IMPORTANT SAFETY RECALL

Bulletin Number: NHTSA Recall 18V-832
Product Line: 2019 Airstream Interstate 19
Subject: Incorrect Battery Fuse

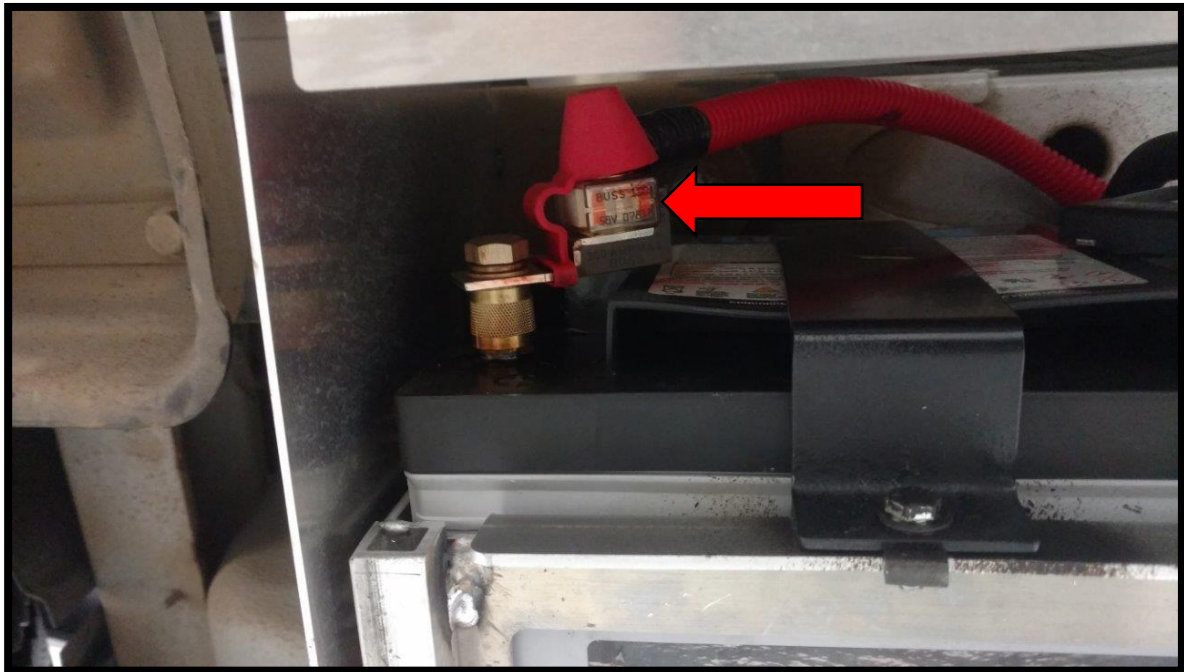
Step 5: Disengage the red rubber cap and, using the 13mm wrench, remove the containment nut on the positive fuse. Remove lock washer, flat washer and positive cable from the fuse side stud.

Then remove the 150Amp fuse and replace with 100Amp fuse.

Reconnect the positive cable, flat washer, lock washer and nut on the 100 Amp fuse. Using the inch lb. torque wrench, torque nut to 70 inch lbs.
